SERVICE BULLETIN NO. 152A
(SUPERCEDES SERVICE BULLETIN NO. 152
"FAA DOA EA-4 APPROVED")

SUBJECT: UPPER COWL CENTER HINGE REPLACEMENT

SERIALS AFFECTED: AA5-0641 thru AA5-0834, AA5A-0001 thru AA5A-0050,
AA5A-0054 thru AA5A-0056, AA5B-0001 thru AA5B-0169,
AA5B-0171 and AA5B-0180 thru AA5B-0183.

Figure 1. Upper Cowl Center Hinge Replacement

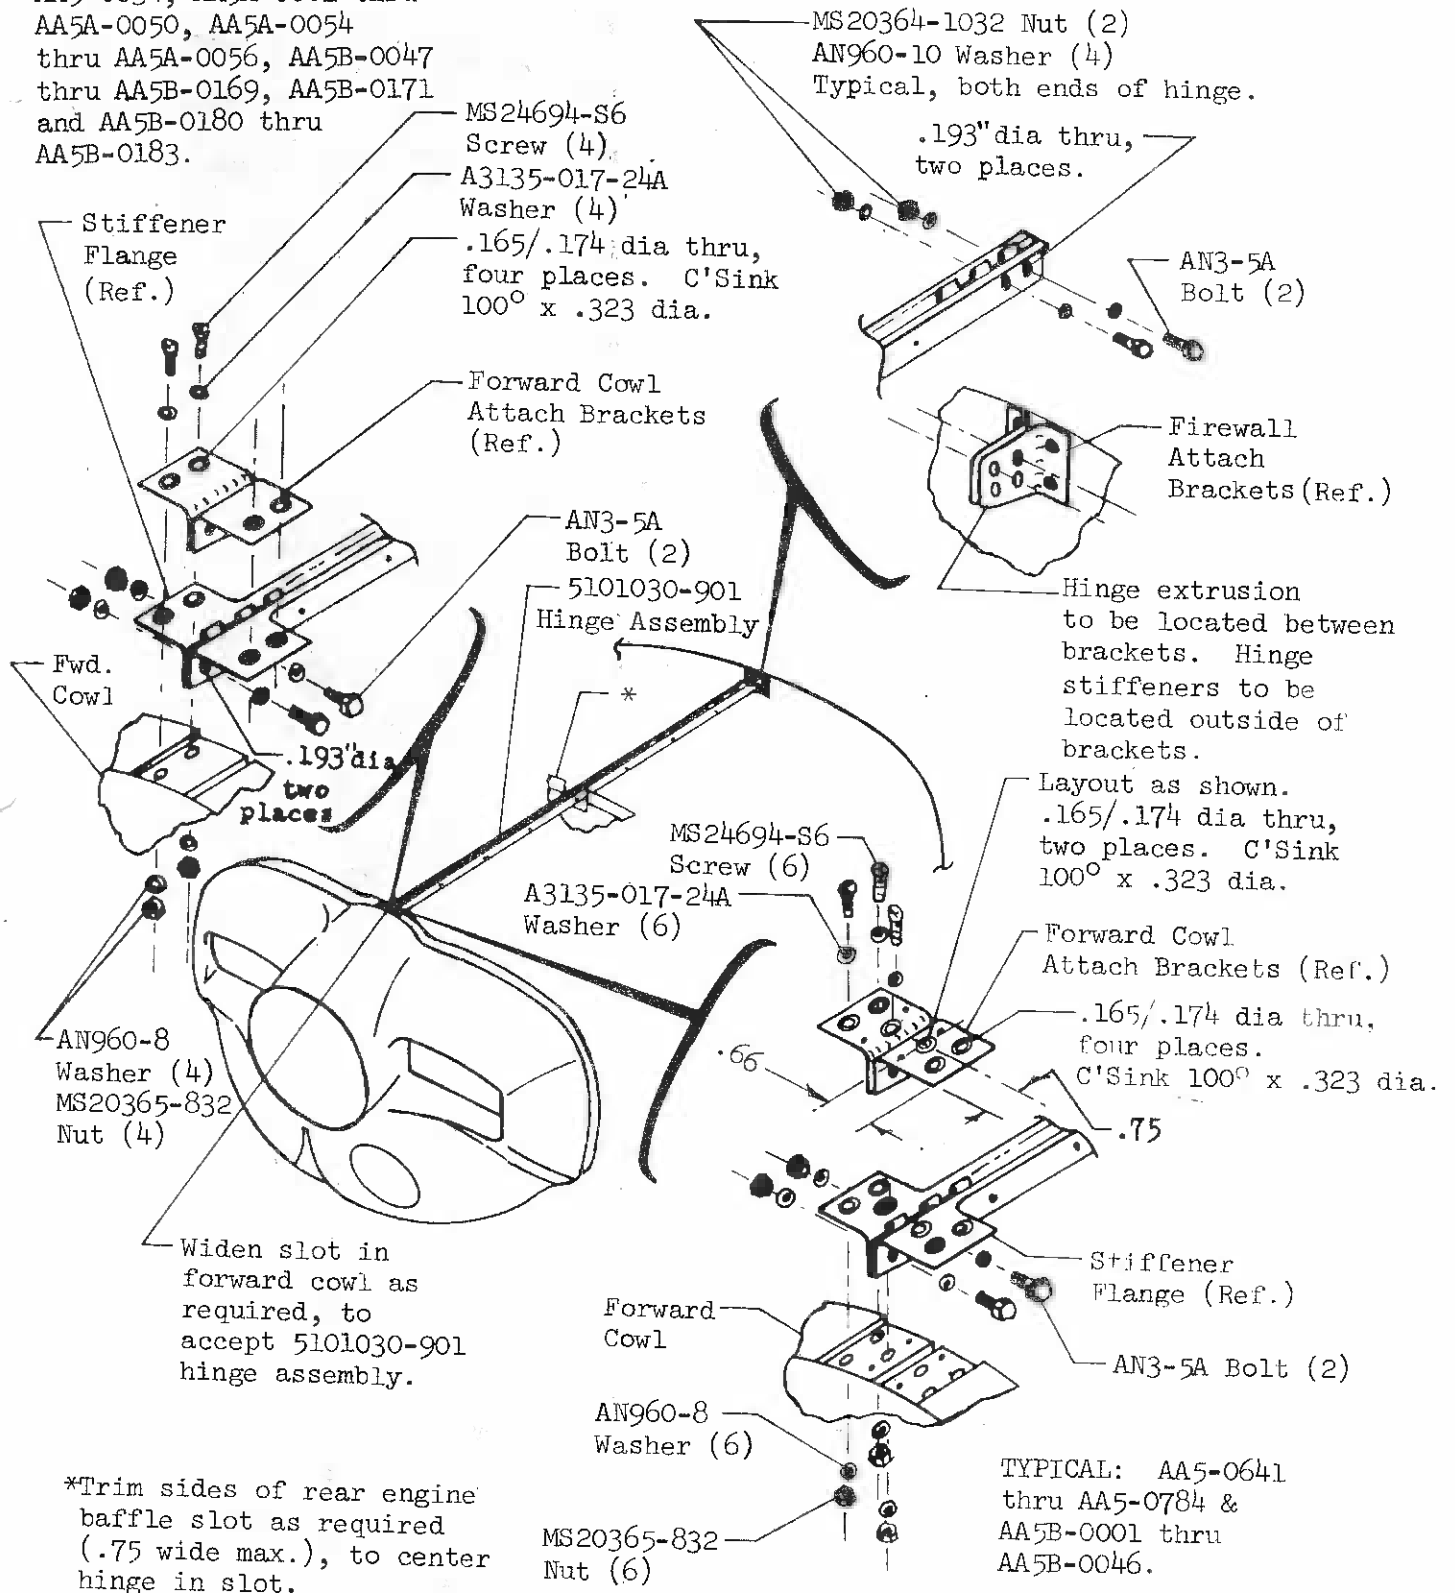
A few instances of upper cowl hinge assembly failures have recently been reported on the model AA-5B aircraft. Cracks develop at the center hinge adjacent to the forward and aft attach brackets and progress to failure unless detected by inspection.

A new improved center hinge assembly has been developed to eliminate this failure mode. The new assembly is retrofitable on the above affected aircraft.

Visually inspect the upper cowl hinge assembly adjacent to the forward and aft attach brackets for cracks. If cracks are detected, the hinge assembly must be replaced before further flight with the improved center hinge assembly.

1. Remove the upper cowl in accordance with the current model service manual.
2. Separate the original hinge assembly from the right and left upper cowl halves by removing the hinge pin.
3. The improved center hinge assembly is undrilled. The forward and aft attach bracket holes should be laid out from the original hinge. Holes should be drilled to .193".

4. Remove the forward cowl attach brackets; on AA5-0641 thru AA5-0784 and AA5B-0001 thru AA5B-0046, remove the eight (8) rivets that attach the brackets to the forward cowl.

On AA5-0785 thru AA5-0834, AA5A-0001 thru AA5A-0050, AA5A-0054 thru AA5A-0056, AA5B-0047 thru AA5B-0169, AA5B-0171 and AA5B-0180 thru AA5B-0183, remove the four (4) MS24694-S5 Screws that attach the brackets to the forward cowl.

5. Temporarily attach the forward attach brackets to the hinge assembly with the stiffeners outside of the brackets, utilizing the hardware shown in Figure 1.
6. Temporarily attach the hinge assembly to the firewall attach brackets with the stiffeners outside of the brackets utilizing the hardware shown in Figure 1.
7. On AA5-0641 thru AA5-0784 and AA5B-0001 thru AA5B-0046, match drill the forward stiffener flanges of the new hinge assembly to the two (2) existing outboard rivet holes already drilled in each of the attach brackets and forward cowl. Locate a third hole .75" from the leading edge and .66" from the outboard edge in each forward cowl attach bracket. Drill all six (6) holes to .165/.174 inch dia and countersink to 100° x .323 inch dia.

On AA5-0785 thru AA5-0834, AA5A-0001 thru AA5A-0050, AA5A-0054 thru AA5A-0056, AA5B-0047 thru AA5B-0169, AA5B-0171 and AA5B-0180 thru AA5B-0183, match drill the forward stiffener flanges of the new hinge assembly to the four (4) existing holes already in the attach brackets and forward cowl. Drill all four (4) holes to .165/.174 inch dia and countersink to 100° x .323 inch dia.

THE SLOT ALREADY IN FORWARD COWL ASSEMBLY MAY HAVE TO BE SLIGHTLY WIDENED TO ACCEPT ADDITIONAL THICKNESS OF THE NEW HINGE ASSEMBLY.

8. Remove hinge from aircraft and deburr all holes.
9. Permanently install the forward attach brackets to the new hinge assembly as stated in step 5.
10. Install left and right cowl halves to hinge assembly with hinge pin. Crimp the leading and trailing edges of hinge to retain pin.
11. On AA5-0641 thru AA5-0784 and AA5B-0001 thru AA5B-0046, attach the forward edge of the upper cowl assembly to the forward cowl assembly placing six (6) MS24694-S6 Screws and six (6) A3135-017-24A Washers through the attach bracket, hinge flange and forward cowl assembly and secure them with six (6) AN960-8 Washers and six (6) MS20365-832 Nuts.

On AA5-0785 thru AA5-0834, AA5A-0001 thru AA5A-0050, AA5A-0054 thru AA5A-0056, AA5B-0047 thru AA5B-0169, AA5B-0171 and AA5B-0180 thru AA5B-0183, only four (4) of the above mentioned hardware is utilized.

12. Permanently install the new hinge assembly to the firewall attach brackets as stated in step 6.
13. Locate a slot in the aluminum rear engine baffle where the hinge passes through the baffle. Trim sides of slot as required (.75" max.) to center the hinge in the slot and to insure no contact is made between the hinge and baffle during start up and shutdown. Do not disturb baffle flexible seal.
